ELBERT P. EPLER
NUCLEAR SYSTEMS CONSULTANT
712 FLORIDA AVENUE
OAK RIDGE, TENNESSEE 37830
483-0994

The Oconee breaker failures which you have called to our attention are instructive. I have discussed the matter with S.J. Ditto who concurs with the attached discussion.

By letter, 5-26-79 to W. Kerr, ATWS subcommittee chairman, A. Bates has called to our attention four failures of scram breakers within a period of three weeks at Oconee Units 1 and 3. These are tabulated as follows.

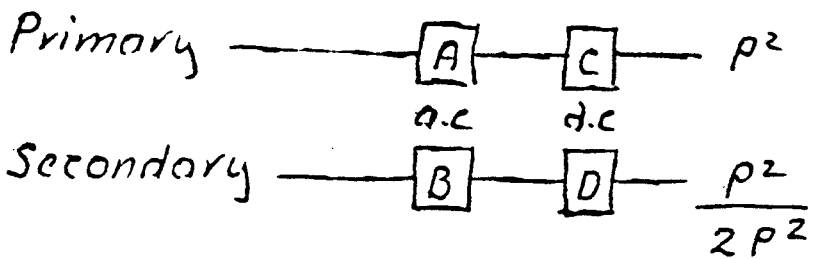
The breakers are shown schematically below.

In order to scram, breakers A, or C, plus B, or D, must be tripped. Failure probabilities are as follows

p = Failure probability of one breaker
 p^2 = Failure probability of primary, or secondary
 $2p^2$ = Failure to scram from this source.

To achieve a modest scram failure probability of $5 \times 10^{-5}/\text{Ryr}$ from this source, with 6 demands per year, $2p^2 = \frac{5 \times 10^{-5}}{6}$, $p = 2 \times 10^{-3}/\text{demand}$.

This corresponds to one failure in 40 years for each breaker when tested once per month. We have seen in three weeks, four failures in a group of 8 breakers, and can not be assured that the remedy, the minor adjustment, is effective. This matter should be pursued.
